Request for Qualifications - RFQ No. 2023-04 Idaho Water Resource Board Design-Build Contract for the Mountain Home Air Force Base Water Resilience Project

Addendum No. 1 Responses to Questions

2.1 includes the following:

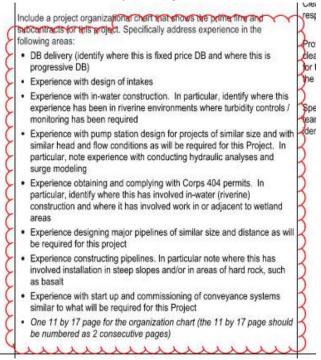
- **Question 6:** Table 7-1 outlines submittal requirements and evaluation considerations. In this Table, RFQ Section 2.1 and 2.2 appear to require overlapping information.

Question Comments: As written, our response to 2.1 and 2.2 would contain overlapping information. This seems unnecessary. Please review and confirm desired submittal requirements.

Answer 6: Section 2.1 is about the experience and the capacity to deliver of the <u>firms</u> that form the Design-Builder team.

Section 2.2 is about the experience of the Design-Builder project team **people** and how they have worked together in the past and will work together on this project.
